American
Petroleum
Institute

October 2, 2023

Re: Greenhouse Gas Reporting Rule: Revisions and Confidentiality Determinations for Petroleum and Natural Gas Systems; Docket No. EPA-HQ-OAR-2023-0234

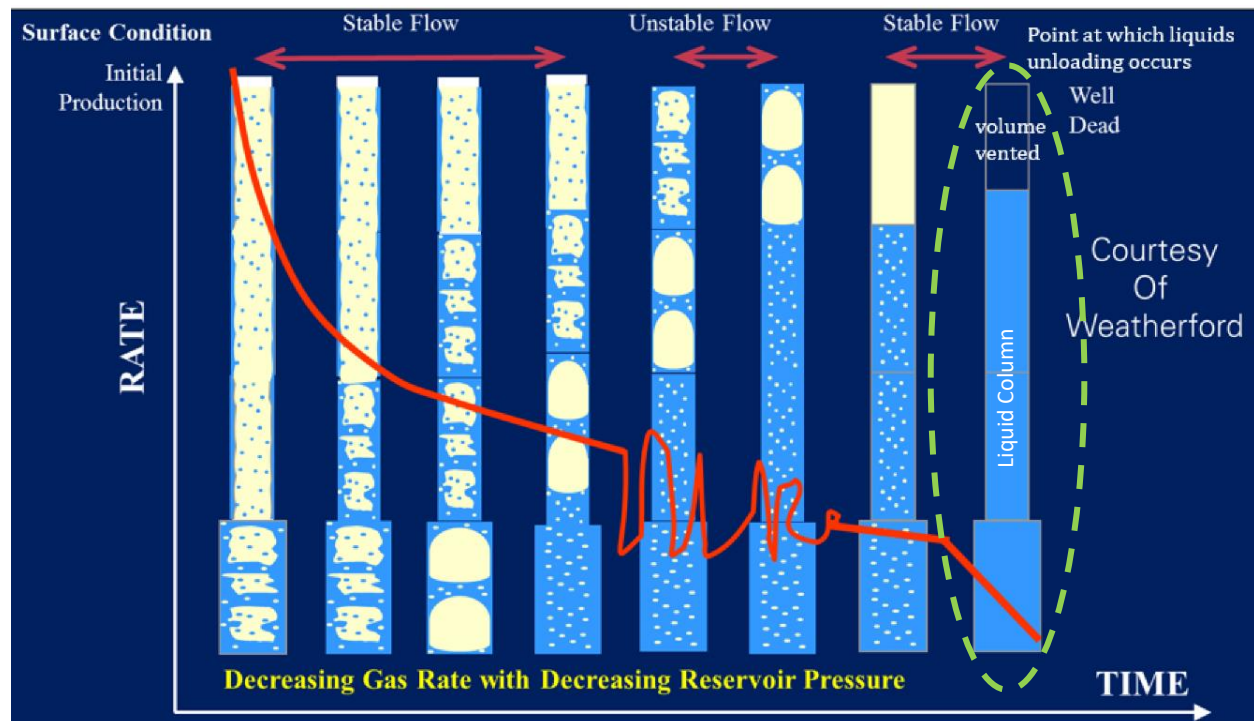
Furthermore, the volume should be able to account for the fluid column depth. EPA should allow companies to determine the depth to the top of the fluid and exclude the remaining volume from the venting volume estimate. The reason for liquids unloading is to remove the liquid column from the well. The volume of liquid should not be considered gas that is vented, and rather only the depth above the fluids should be used to quantify the vented gas, as shown by the 'volume vented' in the following diagram.

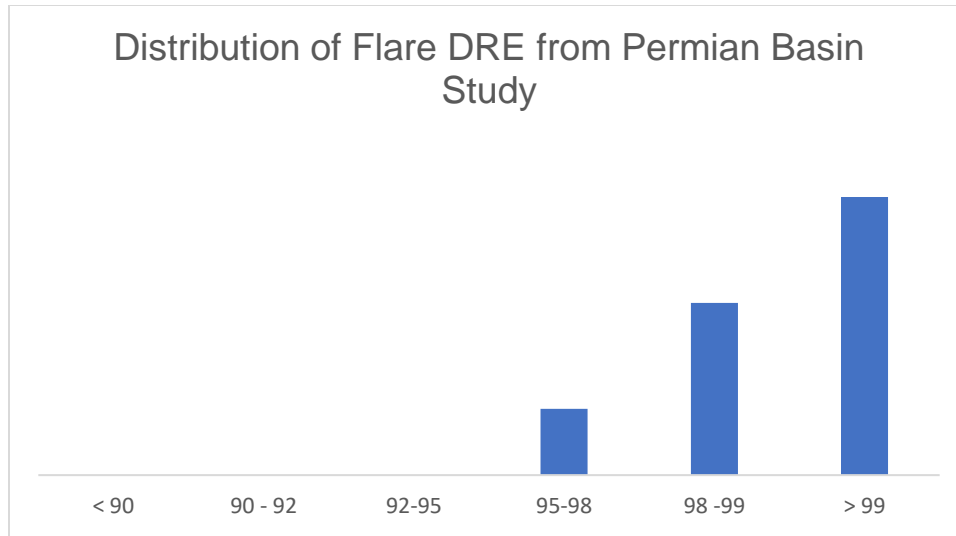
- The study acknowledged that the log-normal curve-fitting technique used likely leads to overweighting the importance of the outlying data, thus magnifying the influence of tails even though the authors noted that the median observed DRE values were close to 98%. Also, the authors could not explain the outlying, tail-defining observations collected (emphasis added), “Investigations into possible drivers of reduced DRE... did not yield compelling explanatory relationships, suggesting that the combination of our airborne sampling and these supplemental datasets *cannot explain most of the observed flare CH₄ DRE variability.*” Also, the authors did not solicit input from operators about operating conditions that could explain the observed
-

data. Given the influence of the low DRE datapoints, further scrutiny as to their validity and possible exclusion from the dataset should have been made.
